Product/Process Change Notice (PCN)

PCN #:
PCN_FeStarFix/FixLFS/Gap/Bueno_20150130_Packaging-Change

Product Affected: 74271633, 74271633S,
74271733, 74271733S, 74272733, 74275813,
74275813S

Tray design and size change for improved handling and transport.
Dimensions change as detailed in the tables below.

Vibrations test setup

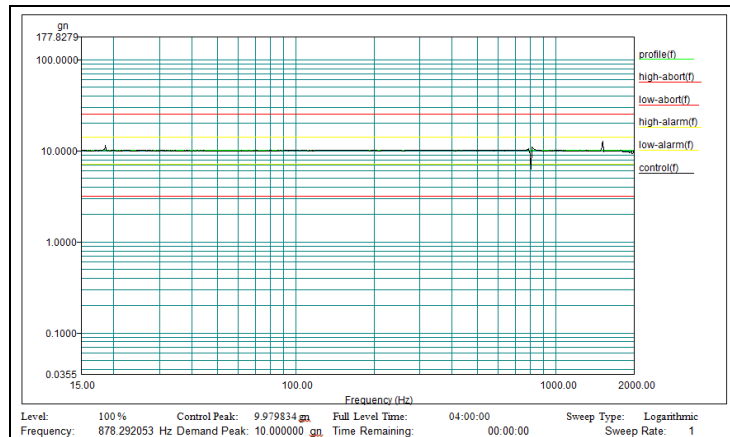
1. Drop test according to *DIN EN 22248 "Packaging; complete, filled transport packages; vertical impact test by dropping (ISO 2248:1985)"* has been done.
2. Vibrations test according to *MIL-STD-202 Method 204* has been done under the following test conditions:
 Acceleration: 10G
 Frequency range: 15-2000Hz
 Duration: 4 hours at Z axis
